# I-Force Linear Motors

Cable Change Reference  
410 Forcer

## Purpose

This document shows the changes made to the cable coming from the Trilogy Linear Motor Forcers. Find the WDx in the part number ordered and then find the old and new wiring illustrations below.

## THF05 Cable Change

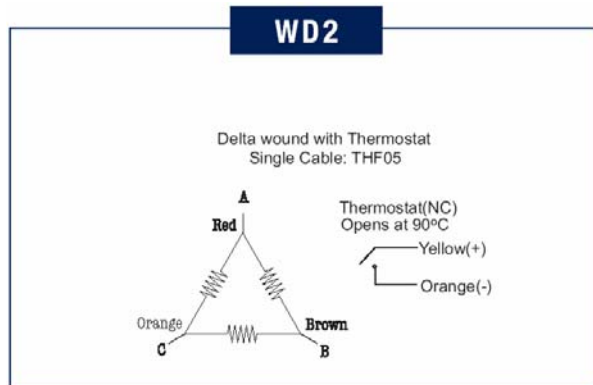
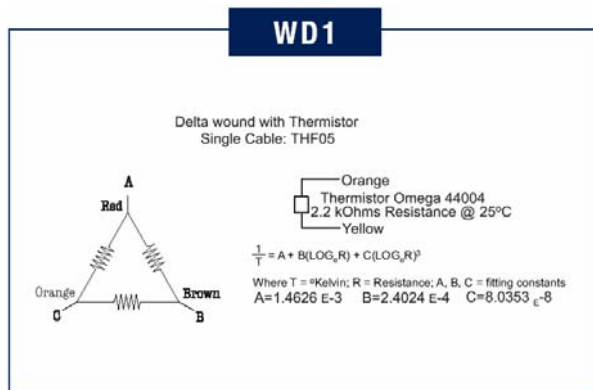
- An 18AWL green/yellow ground wire was added
- A yellow stripe was added to the red, brown and orange phase wires
- Outer diameter increased from 0.237" to 0.267"
- Cable meets certain UL requirements as marked

## 410 Forcers – Single Cable

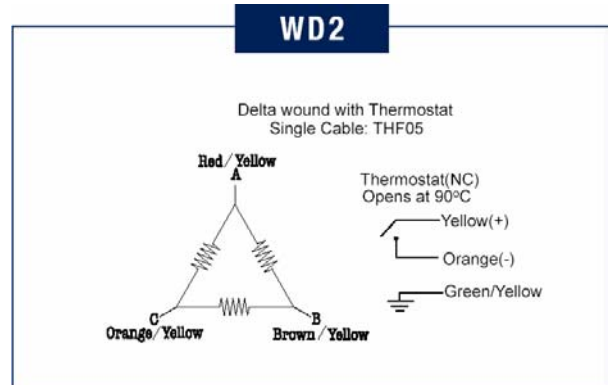
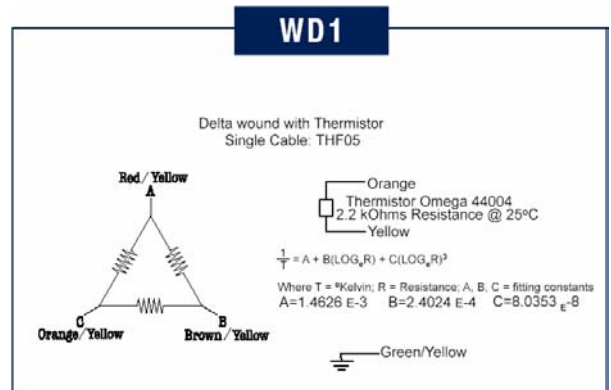
- Old cable is noted on left of page, new cable on right. NOTICE COLOR CHANGES.

## 410 Forcers – Dual Cable

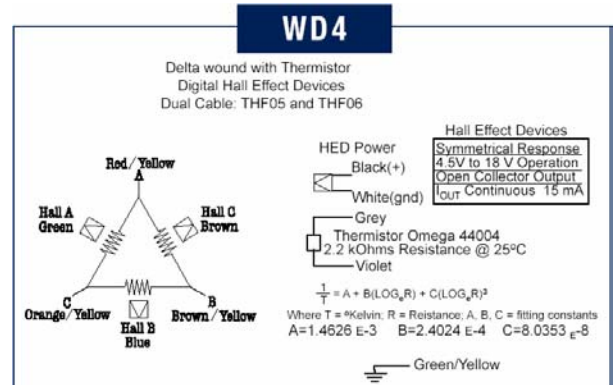
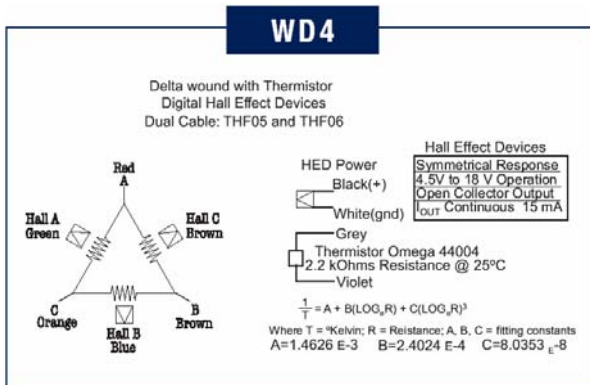
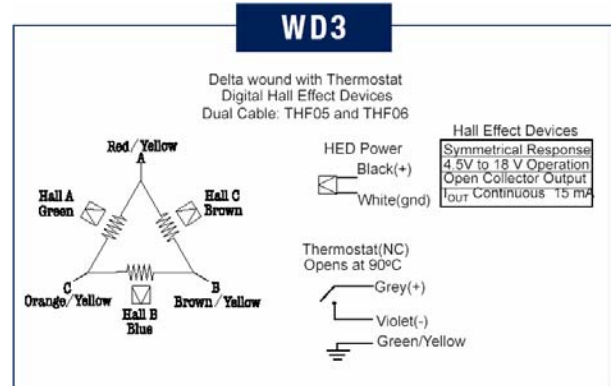
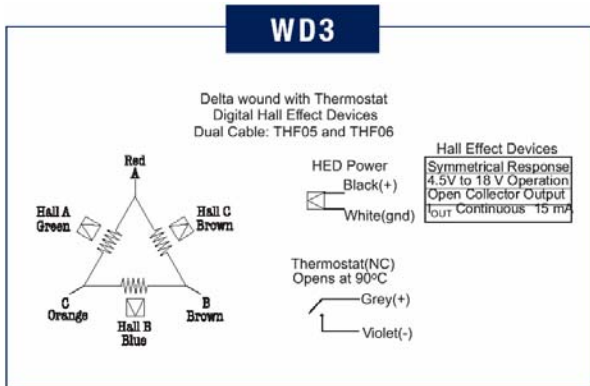
- NOTE: THF06 has not changed
